TECHNICAL COMMITTEE RECOMMENDATION

TECHNICAL COMMITTEE: Signals Technical Committee

TOPIC: **Proposed new Section 4C.10 Warrant 9, Intersection
Near Highway-Rail Grade Crossing**

Figure 4C-9. Warrant 9, Intersection Near Highway-Rail Grade Crossing (One Approach Lane at Track Crossing)

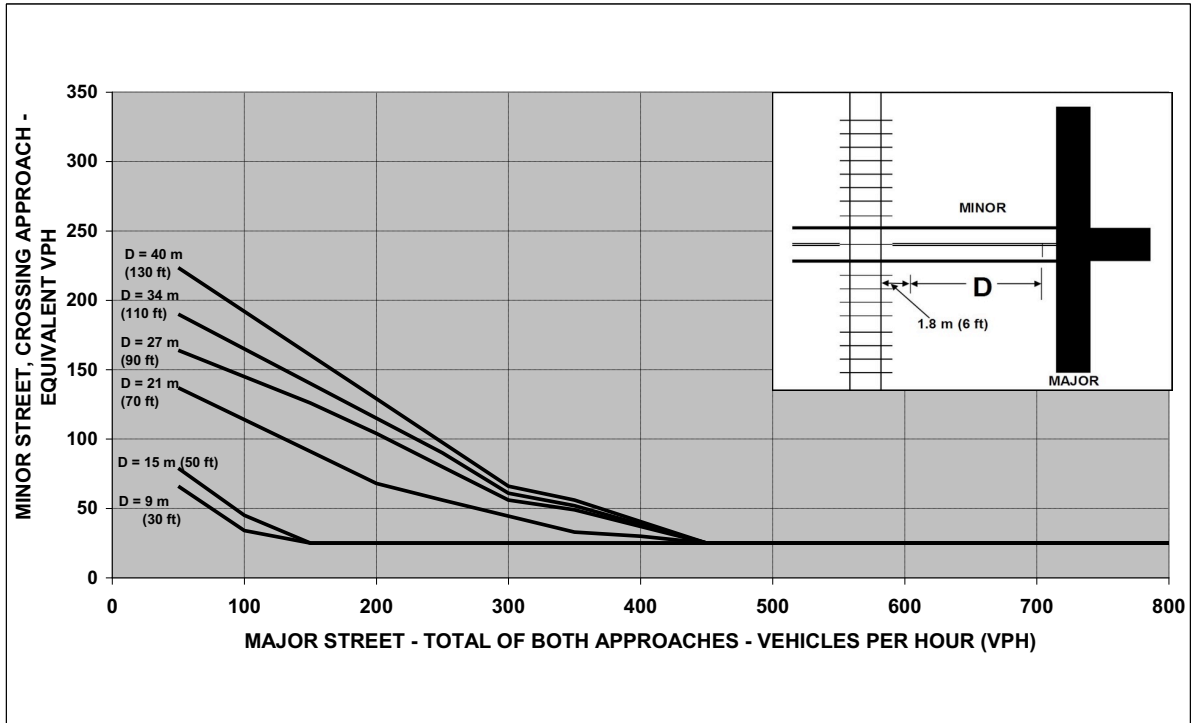
The new figures included in this new section were originally labeled 4C-5 & 4C-6. However, new figures 4C-5 through 4C-8 were approved as part of the revisions to Section 4C.05. Therefore, the two new figures for this new section are now labeled 4C-9 & 4C-10. The text has been updated to reflect this. These changes are considered editorial.

- A. A highway-rail grade crossing exists on an approach controlled by a STOP or YIELD sign and the center of the track nearest to the intersection is within 43 m (140 ft) of the stop line on the approach;**
- B. During the highest traffic volume hour during which trains use the crossing, the plotted point representing the vehicles per hour on the major street (total of both approaches) and the corresponding vehicles per hour on the minor-street approach that crosses the track falls above the applicable curve in Figure 4C-9 or 4C-10 for the existing combination of approach lanes over the track and the distance D.**

- A. Use Figure 4C-9 if there is only one lane approaching the intersection at the track crossing location. Use Figure 4C-10 if there are two or more lanes approaching the intersection at the track crossing location.
- B. After determining the actual distance D, use the curve for the distance D that is nearest to the actual distance D. For example, if the actual distance D is 28 m (95 ft), compare the plotted point to the curve for D = 27 m (90 ft).
